Purdue University, Fort Wayne
Visual Arts Building Art Gallery Addition - 2026 (PU's C.20.10232 | DC's 20250244)
08/17/2026

ADDENDUM NO. 3

1 POWER PLAN - MAIN LEVEL
SCALE: 1/8" = 1'-0"

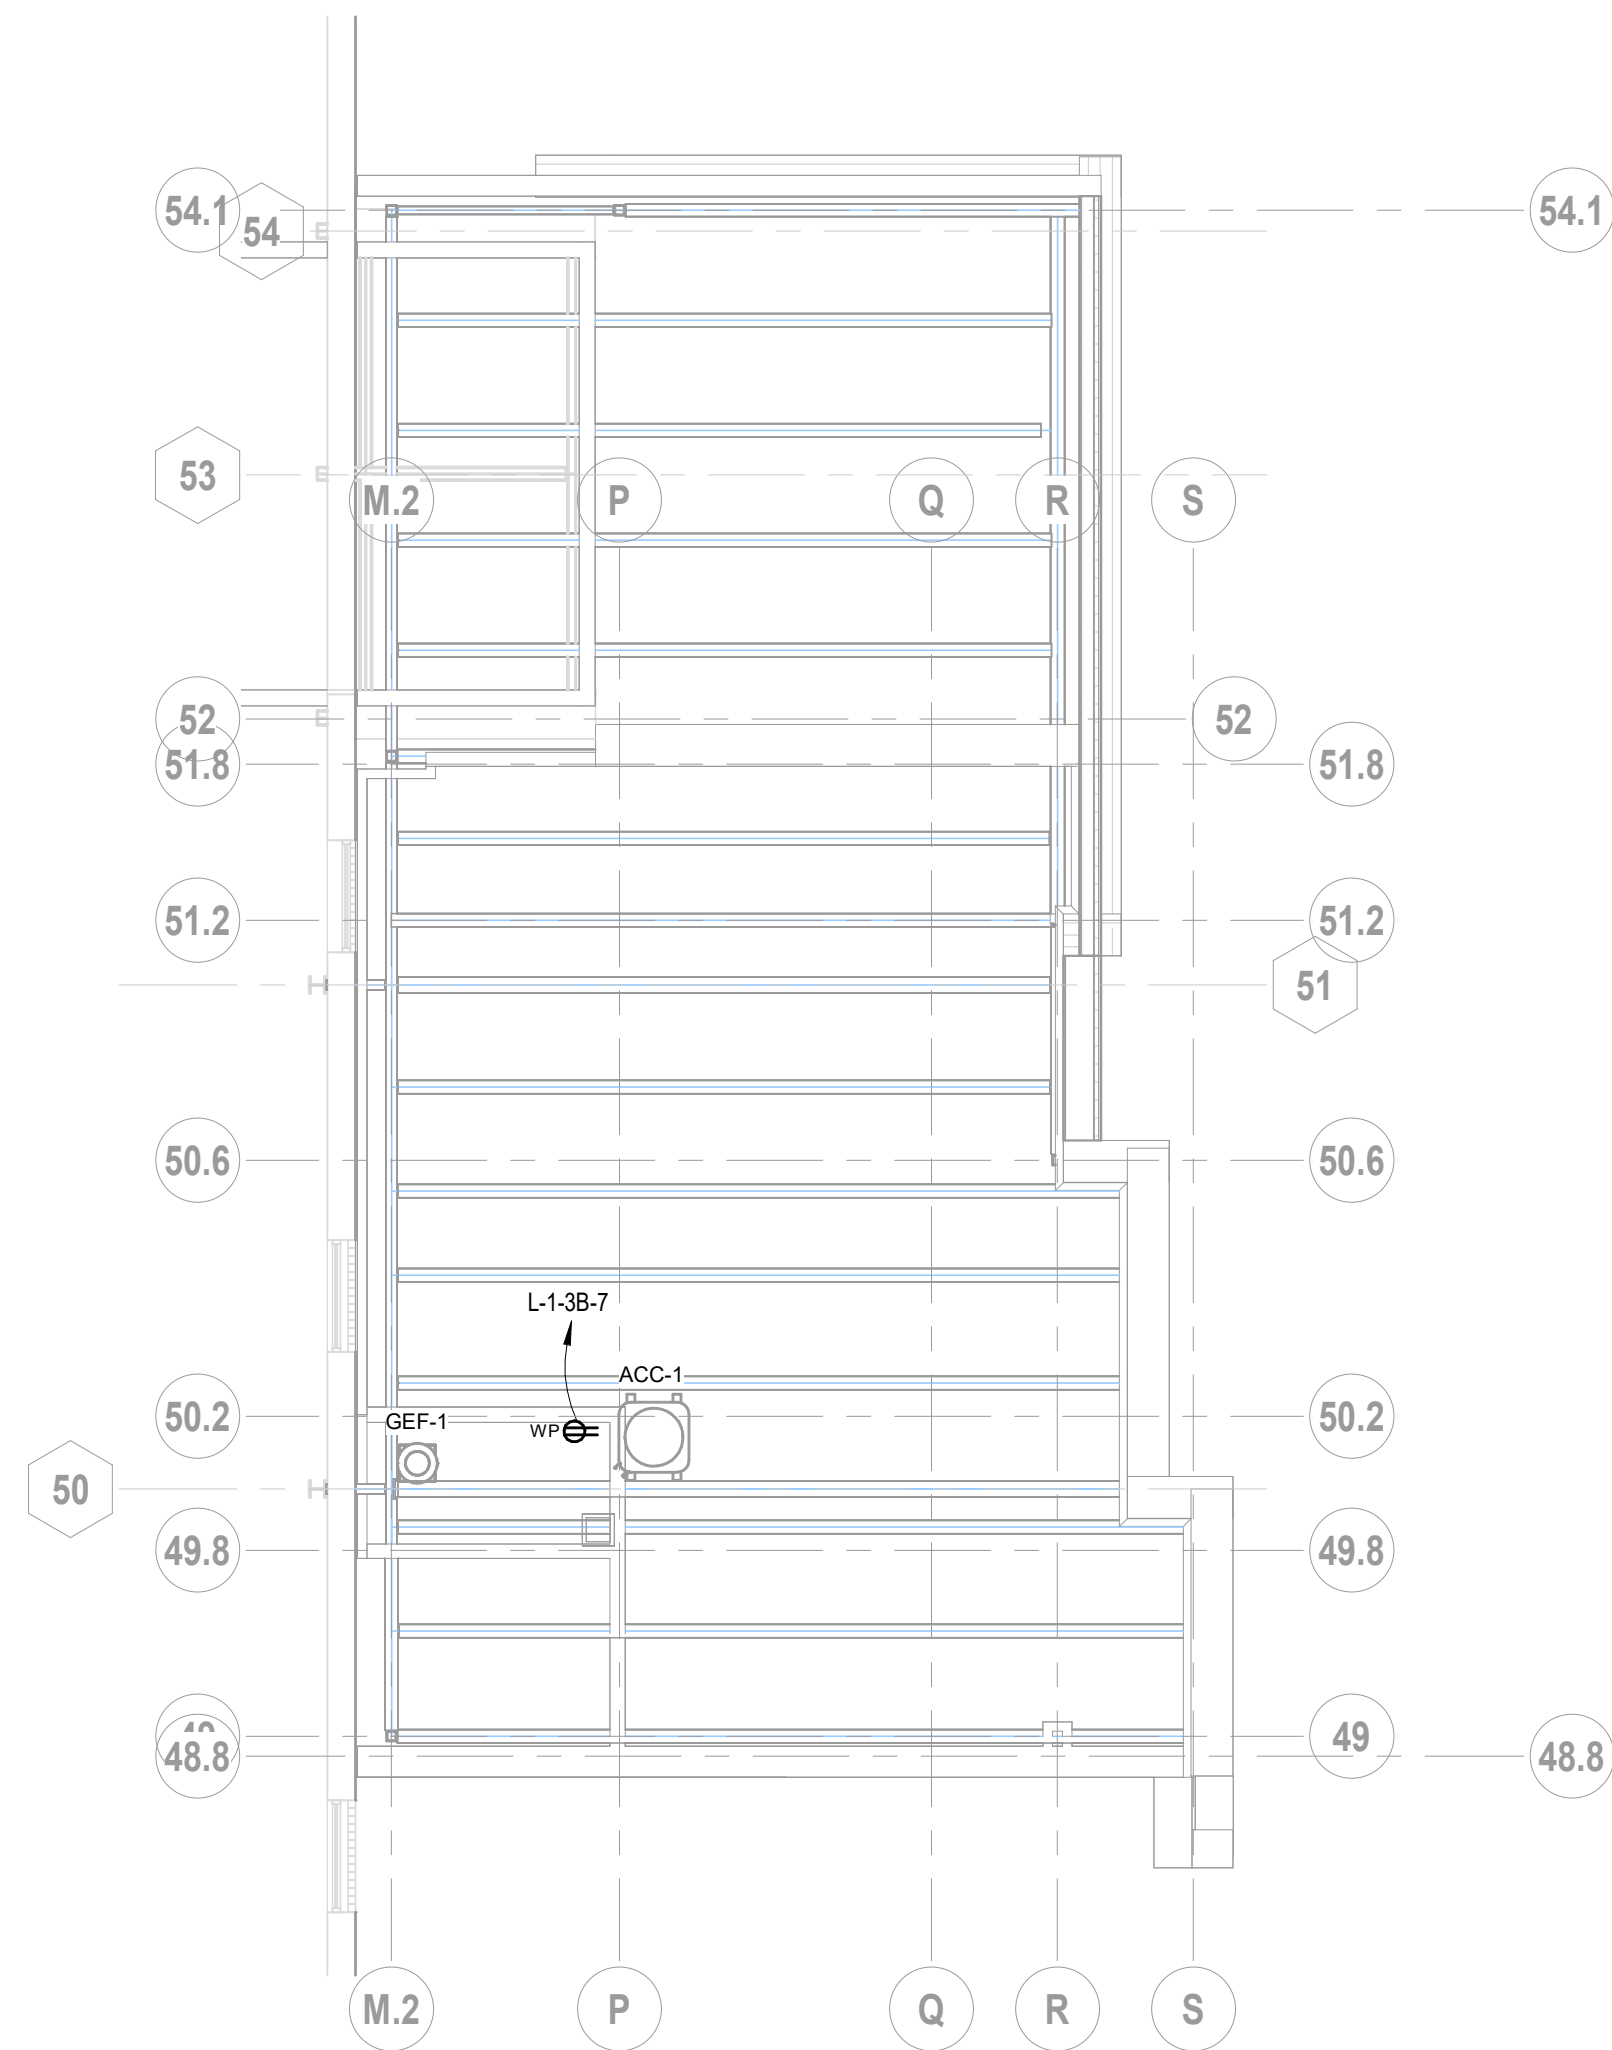
- Item:** **3.04**
Location: Drawings, Sheet E1.1 - Electrical Plans - Main Level
Description: Edited keynote 'EP02' to clarify scope for cameras and WAPs.

POWER PLAN KEYNOTES	
EP01	INSTALL 1-1/4" T CONDUIT BODY, OPENING TO FACE DOWN.
EP02	WAPICAMERA LOCATION SHOWN FOR REFERENCE ONLY. E.C. TO COORDINATE FINAL LOCATION OF DEVICES WITH OWNER AND INSTALL SURFACE MOUNTED DOUBLE GANG JUNCTION BOXES FOR EACH DEVICE. CABLEING AND EQUIPMENT TO BE PROVIDED BY OWNER.
EP03	INSTALL ONE 1-1/4" EMT 12 AFF. BUSH ENDS OF CONDUIT.
EP04	PROVIDE 120V POWER TO DAMPER FROM GEF-1 CIRCUIT.

5 TELECOMMUNICATIONS OUTLET DETAIL

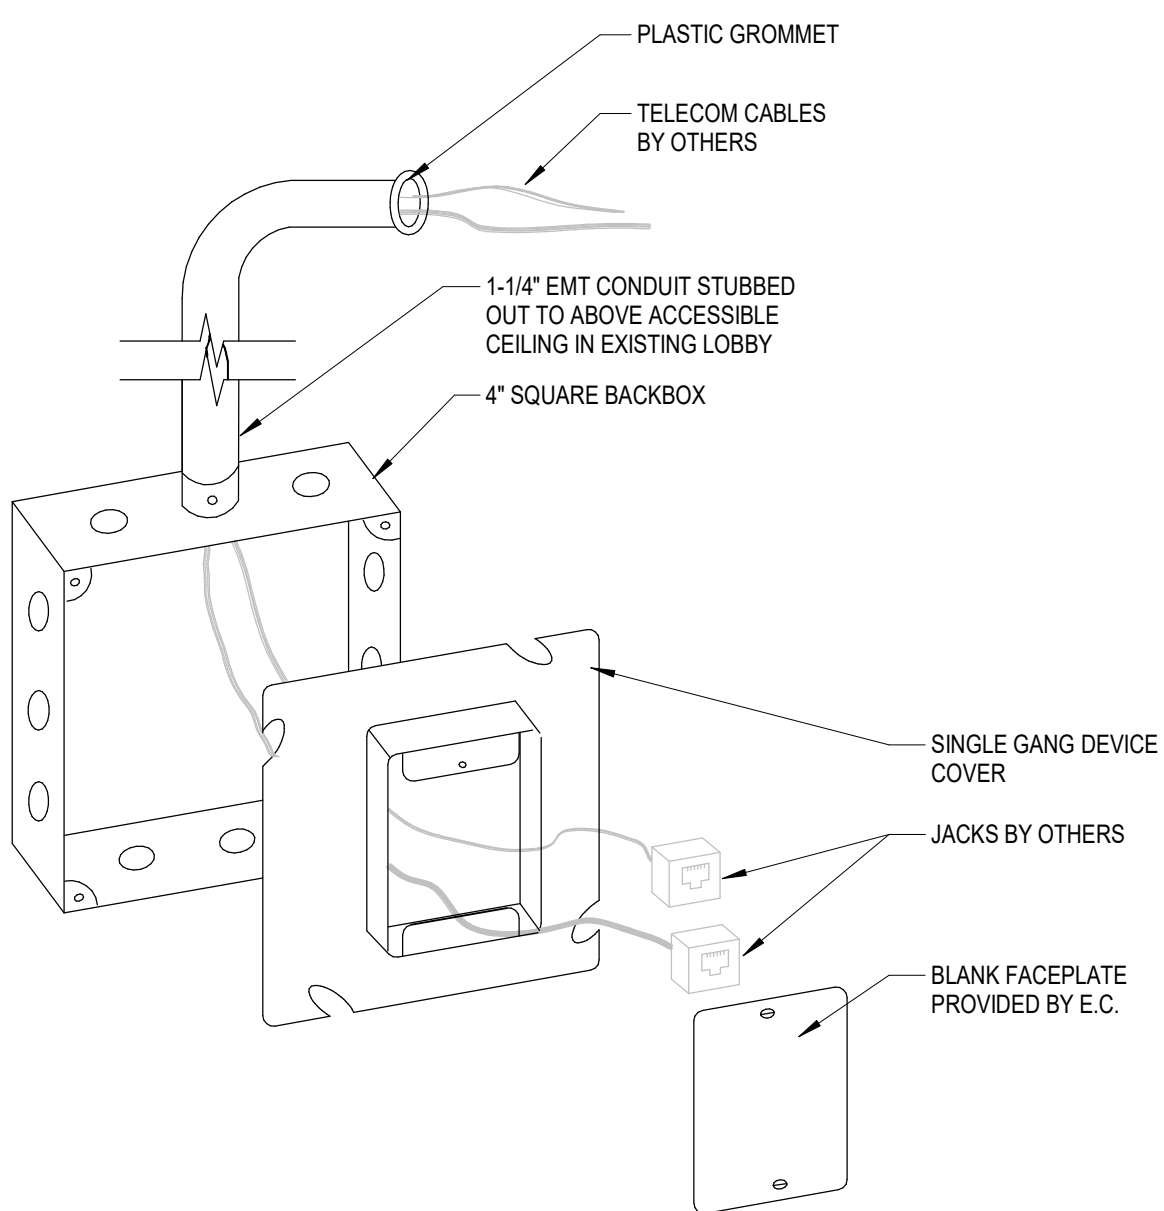
- Item:** **3.05**
Location: Drawings, Sheet E4.2 - Electrical Details & Schedules
Description: Added 'Telecommunications Outlet Detail' to clarify electrical contractor requirements.
